REV NO. <b>21</b>	TITLE <b>CIRCUIT BOARD SPECIFICATIONS</b>	COUNT ON SHEET <b>2</b>
<b>PJK-AL-0656-A01</b>	<b>VALVE POSITION DRIVER 169C4773, 1F1-F3</b> <b>VALVE POSITION DRIVER - AMS 196C2105, 1F1-F4</b> <b>FIRST MADE FOR ENG MARK II 148D164764</b>	SH NO. <b>1</b>

TITLE  
CIRCUIT BOARD SPECIFICATIONS  
VALVE POSITION DRIVER 186C8105, 1F1-F3  
VALVE POSITION DRIVER - AMS 186C8105, 1F1-F4  
FIRST MADE FOR EHC MARK II

FIGURE 4:  $V_{TP7}$  - Transducer fully extended  
 TOP STOP  
 TS

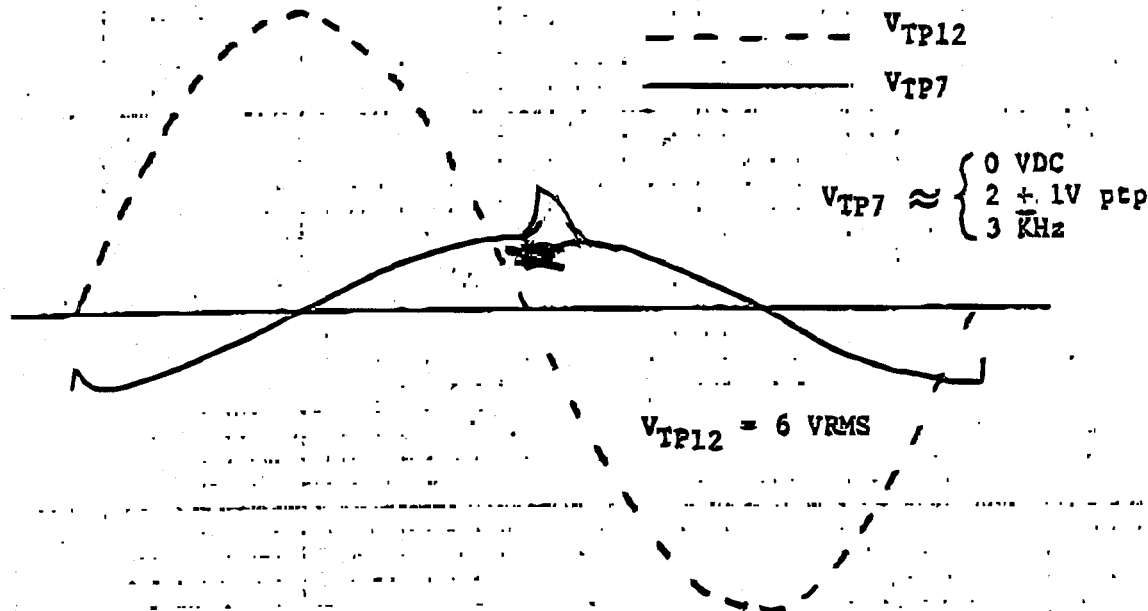
- a. Verify  $V_{TP7}$  by Figure 4. (Use Scope) 50MS SCOPE 20/div
- b. Verify  $V_{TP52}$  by Figure 5. (Use Scope)

FIGURE 6:  $V_{TP7}$  - Transducer Inserted 8" Bottom Stop BS

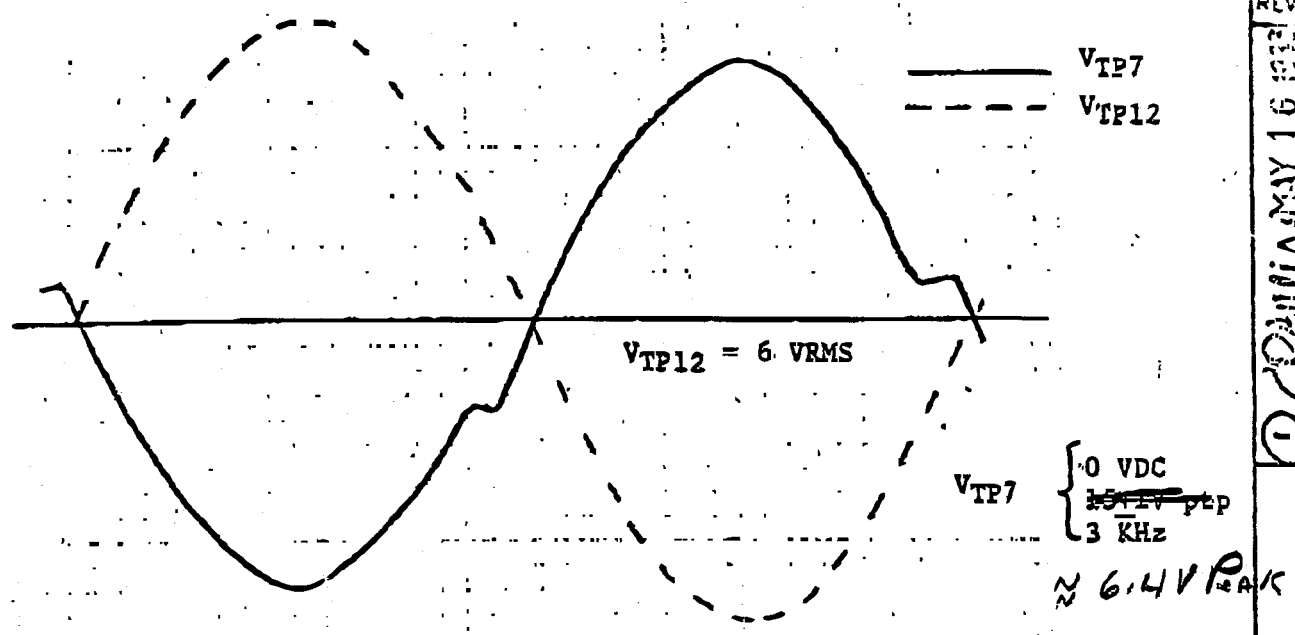
2. Insert the transducer ~~by 0.4~~.  
a. Verify  $V_{TP7}$  by Figure 6.  
b. Verify  $V_{TP52}$  by Figure 7.

to Bottom shaft (2.5" from Body)
